# City of Albuquerque

RE: DRAINAGE PLAN FOR CAPTAIN D's - COORS BLVD. NW  
(G11-D6A1) ENGINEER'S STAMP DATED 8/18/89

## GRADING AND DRAINAGE PLAN

CAPTAIN D'S - COORS BOULEVARD N.W.

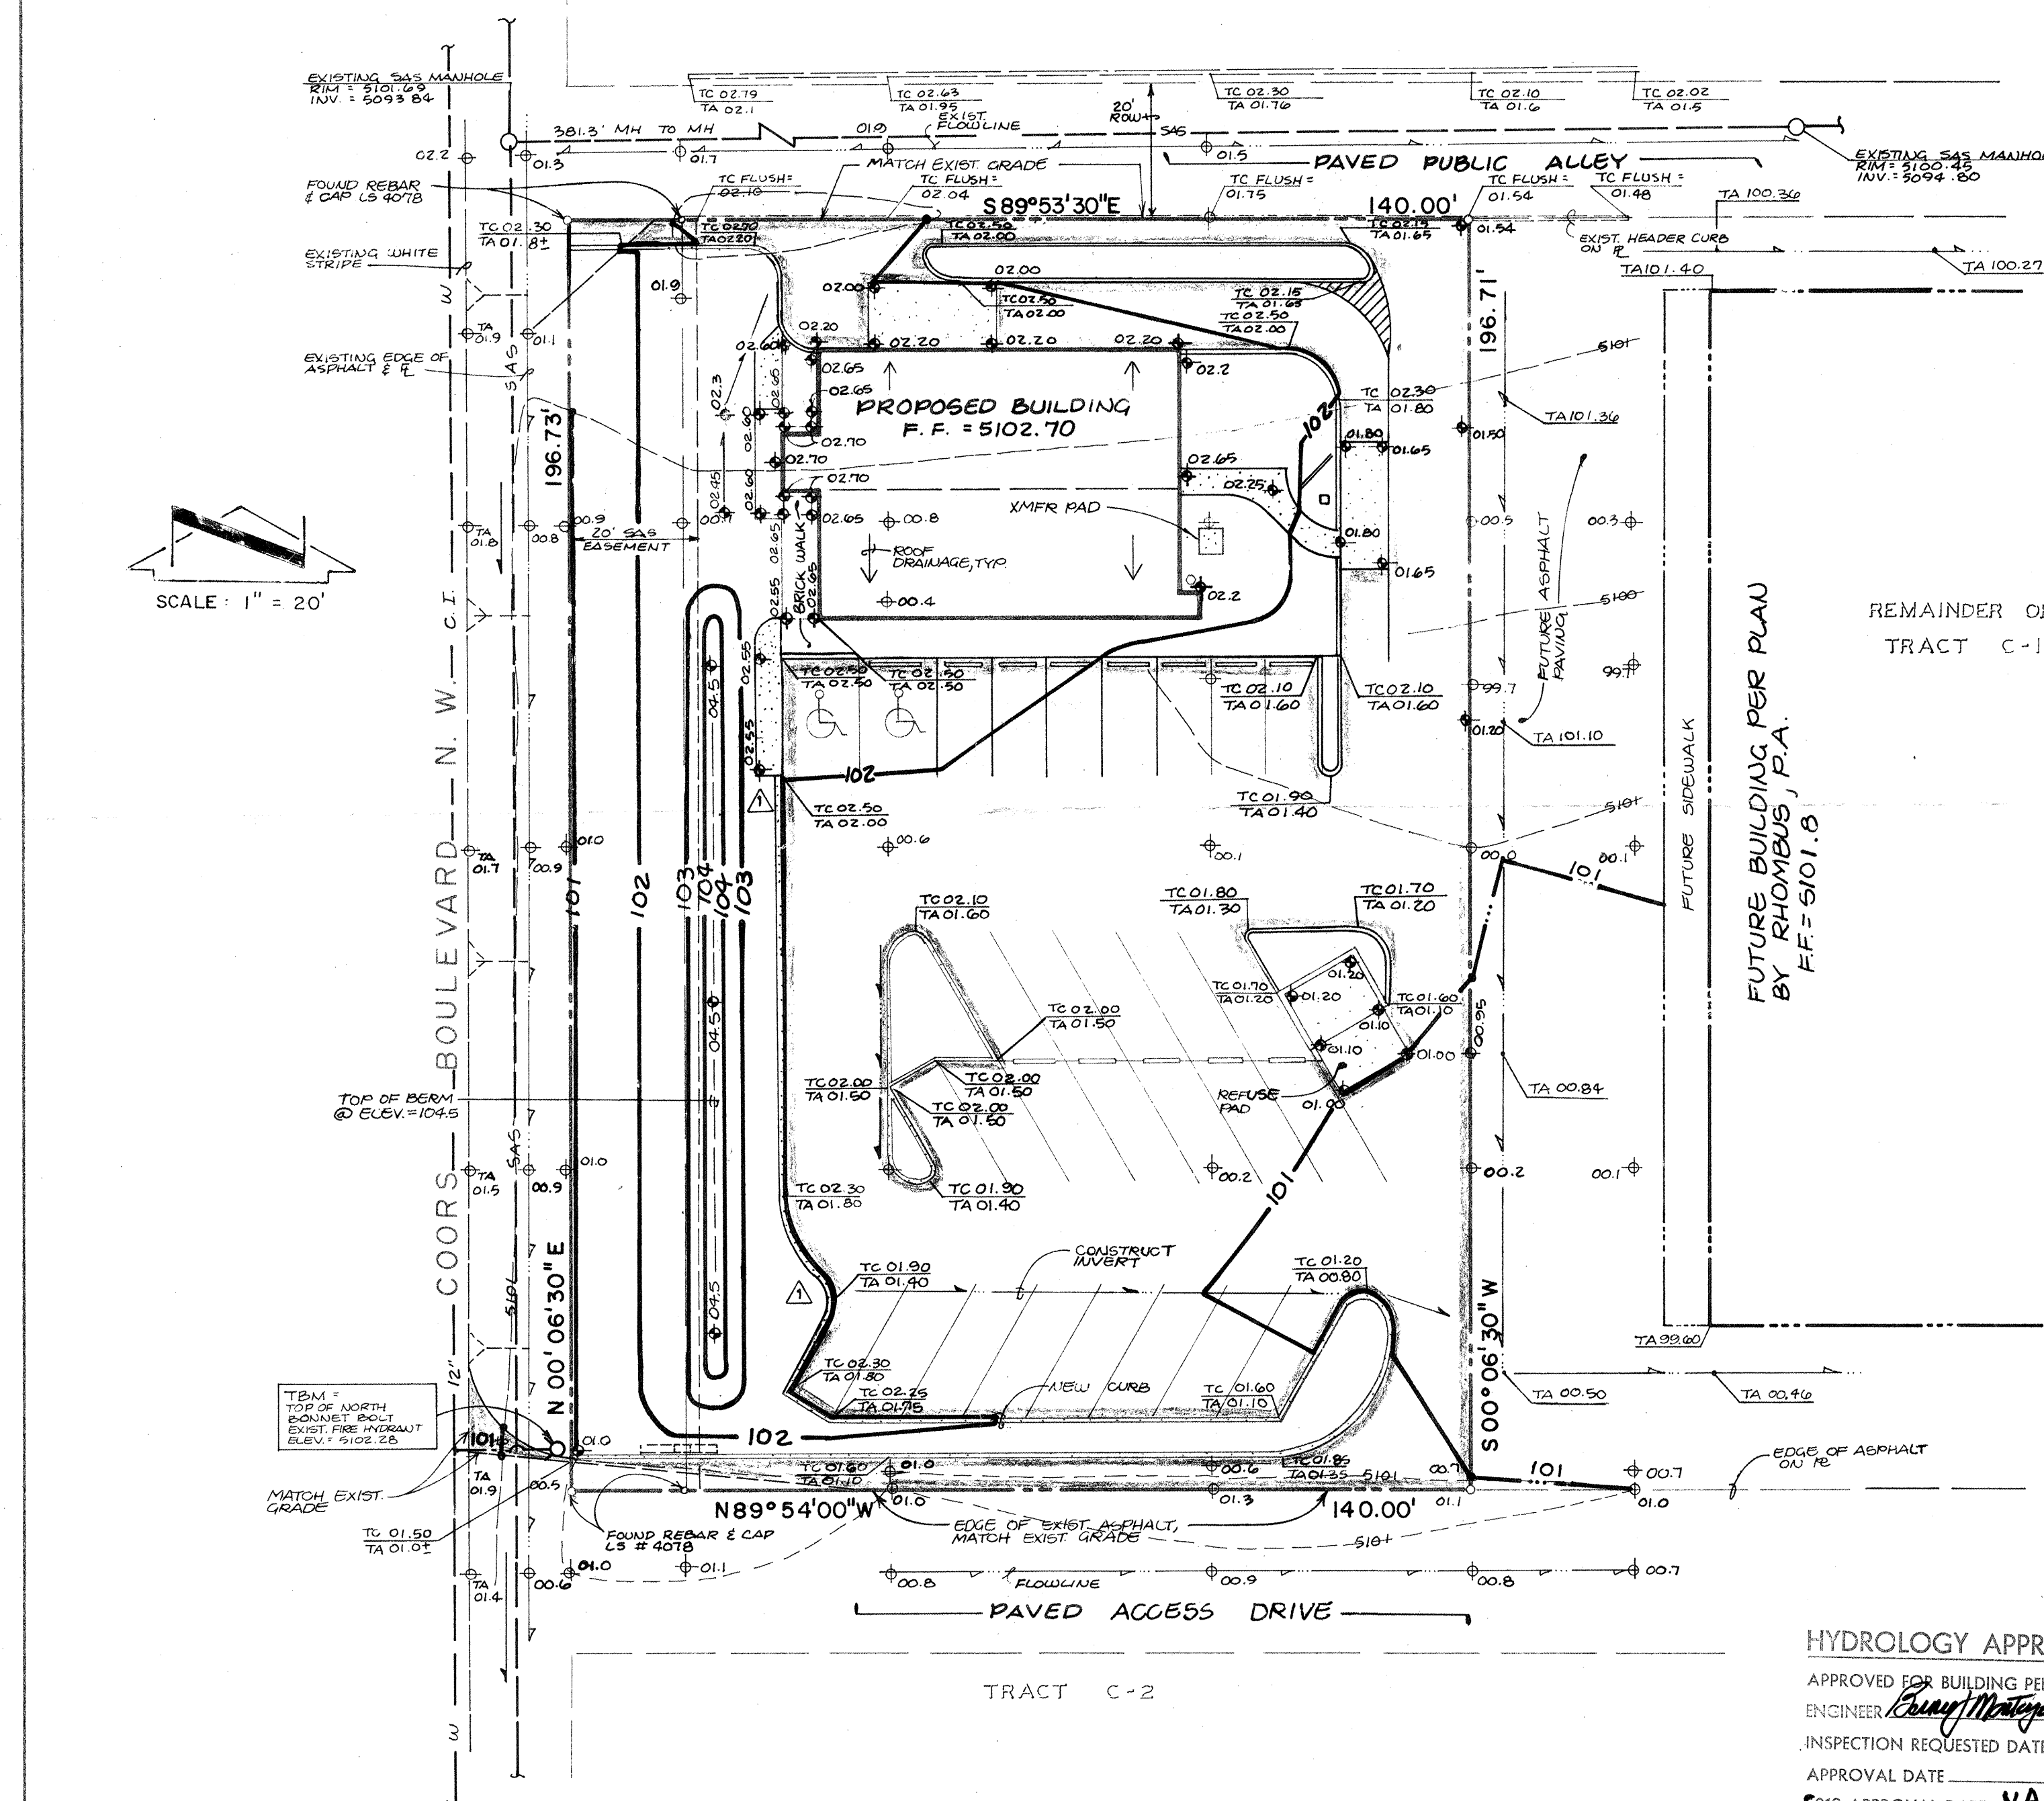
Based on the information provided on your August 22, 1989 submittal, the above referenced drainage plan is approved for building permit and rough grading.

Delay in reviewing this submittal was caused by the fact that the Master Drainage Plan submitted by Rhombus was not approved until October 20, 1989.

Please attach a copy of this approved plan to the construction sets prior to sign off by Hydrology.
